Service Tips

Dual Zone 18+18 Combination

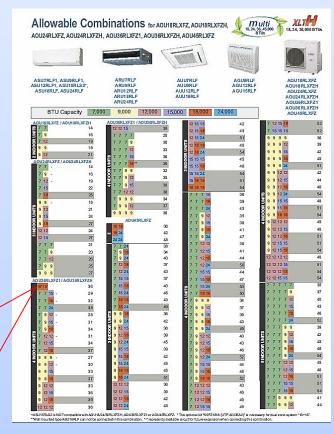
There is a misprint in the current 2016 Fujitsu Catalog that shows a kit is required for an 18+18 combination on the AOU36RLXFZH. However, this kit is only required for the AOU36RLXFZ1. With the AOU36RLXFZH, the 18+18 combination was included in the base of design eliminating the need to upsize the piping.

The optional kit "K9FZ1818 is necessary for dual zone system "18+18" on the AOU36RLXFZ1 only.
